Access Compliance Report Public Rights-of-Way (Curb Ramps)

Main Street: **KINGSWAY_DR** Cross Street: **DOWNING_ST** Location: **NE**

ADA ID: **RPAT211103141023** Ramp Type: **Type 4 - Parallel** Initial Pass/Fail: **Fail** Overall Compliance: **No** Severity Score: **5**

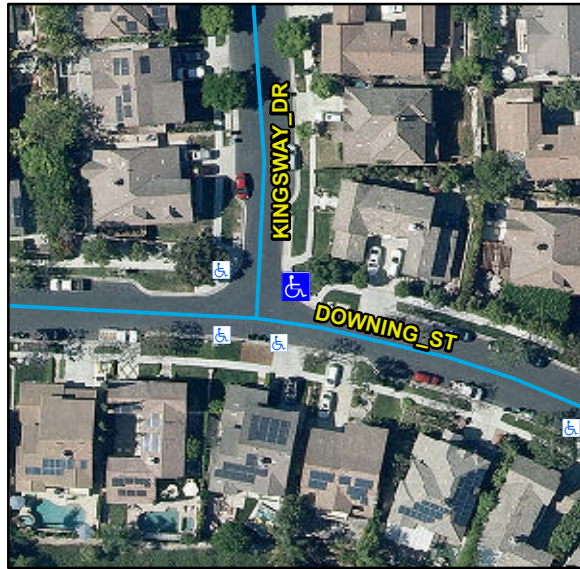
Compliance	Description	Data	Compliance	Description	Data
N/A	Ramp Length LT (in)	90	N/A	Ramp Length RT (in)	85
Yes	Ramp Width LT (in)	48	No	Ramp Width RT (in)	47
Yes	Ramp Run Slope LT (%)	5.8	Yes	Ramp Run Slope RT (%)	6
Yes	Ramp Cross Slope LT (%)	1.9	No	Ramp Cross Slope RT (%)	3.2
N/A	Landing Present	N/A	N/A	DWS Provided	N/A
N/A	Landing Length (in)	N/A	N/A	DWS Contrast	N/A
N/A	Landing Width (in)	N/A	N/A	DWS Length (in)	N/A
N/A	Landing Run Slope (%)	N/A	N/A	DWS Full Width	N/A
N/A	Landing Cross Slope (%)	N/A		DWS Offset Type	N/A
N/A	Landing Movement Obstructed?	N/A	N/A	DWS Offset Left (in)	N/A
	Landing Movement Type	N/A	N/A	DWS Offset Right (in)	N/A
N/A	Landing Shared	N/A			
N/A	Clear Space	Yes			
N/A	Clear Space To Crosswalk (in)	N/A			
N/A	Marked Crosswalk 1	No	N/A	Marked Crosswalk 2	No
	Crossing 1 Direction	W		Crossing 2 Direction	S
	Marked Crosswalk 1 Width (in)	N/A		Marked Crosswalk 2 Width (in)	N/A
N/A	Ramp Inside Crosswalk 1	N/A	N/A	Ramp Inside Crosswalk 2	N/A

Remove & Replace Curb Ramp With Two New Directional Ramps or Equivalent.

R204.3, R304.5.1, R304.5.3, STD 1115
